## **4.0 ERRATA**

This section includes minor edits to the Draft EIR. These modifications resulted in response to comments received during the Draft EIR public review period.

## **4.1 CHANGES AND EDITS TO THE DRAFT EIR**

**Figure 3.9-1**  
FEMA Flood Zone

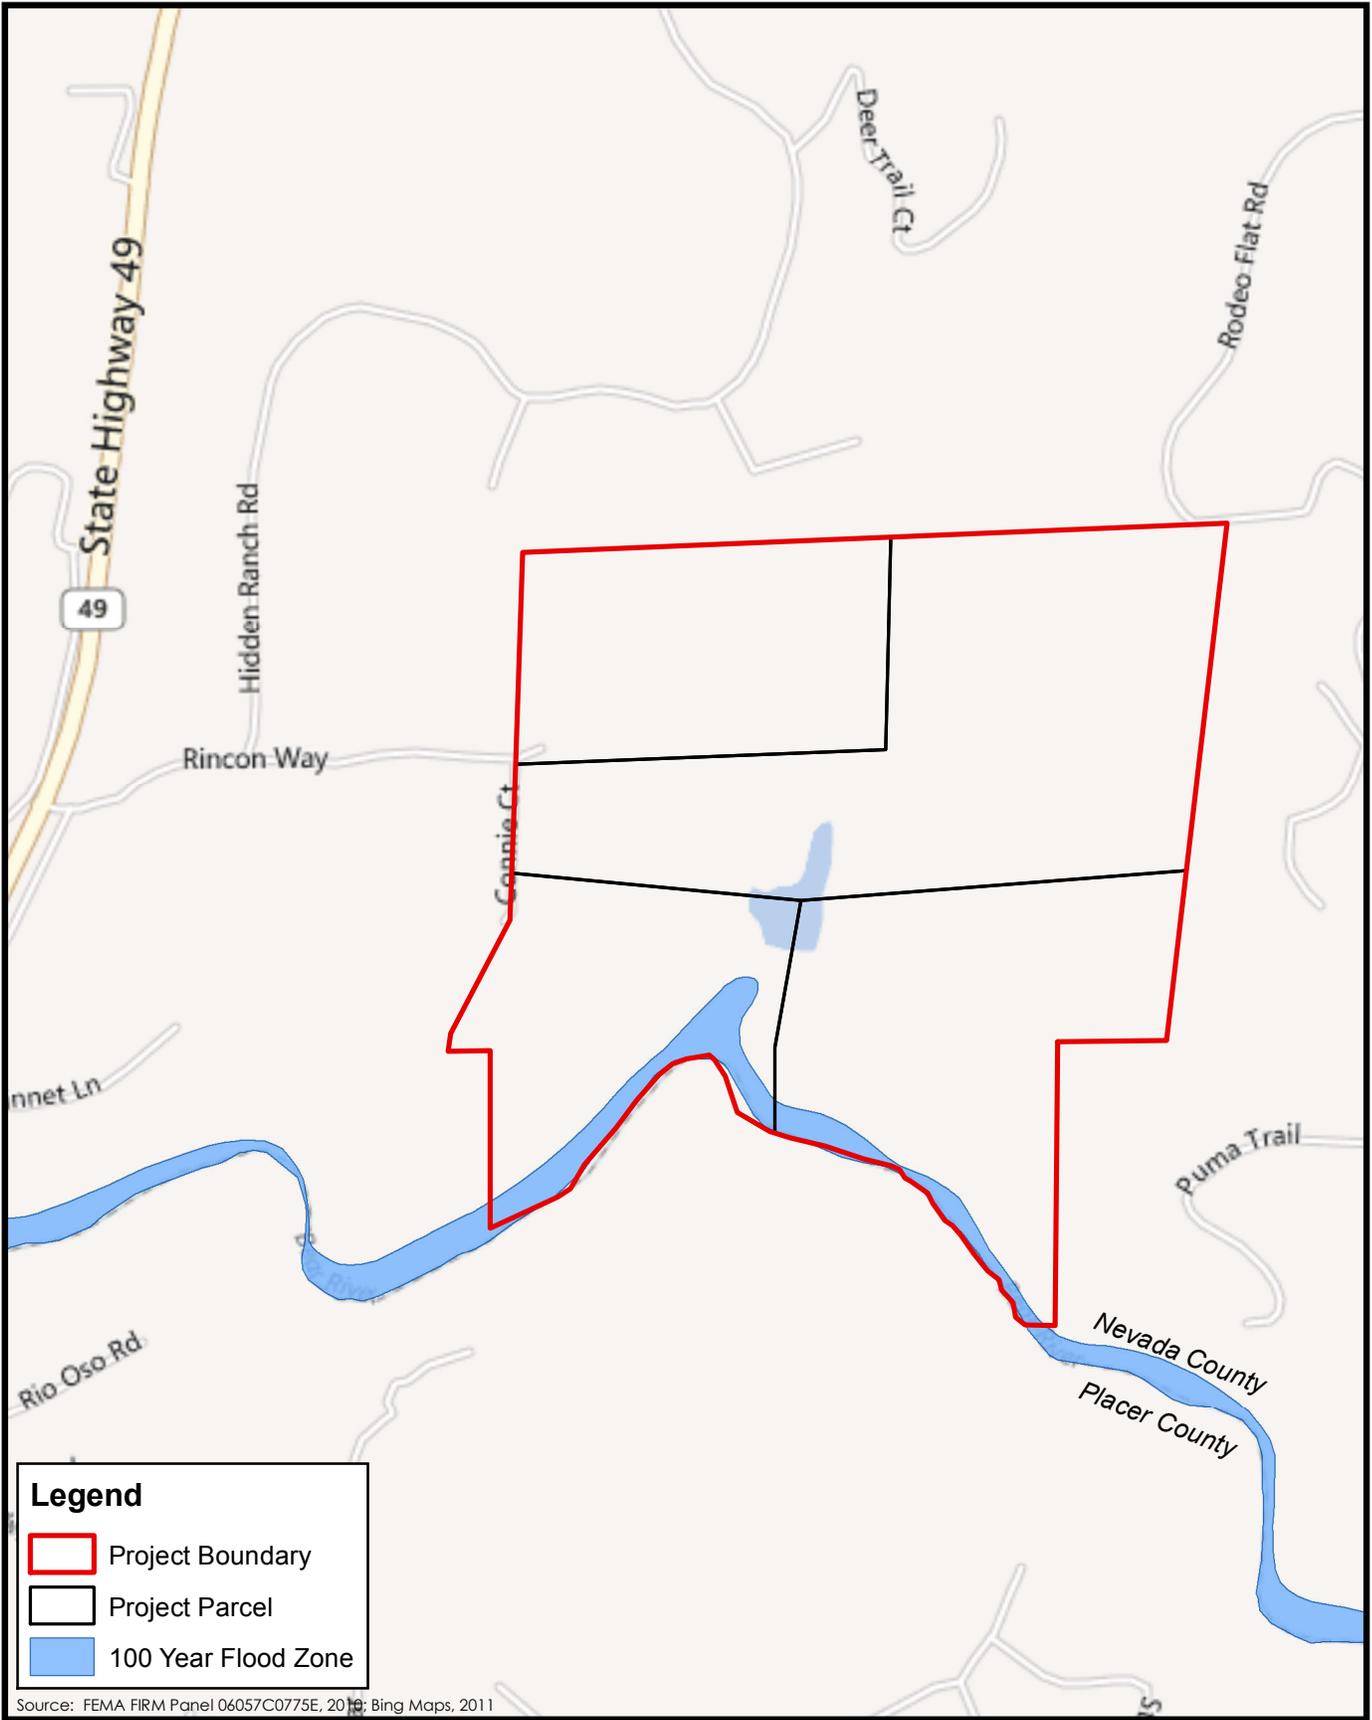
The source of Figure 3.9-1 has been amended on page 3.9-3.
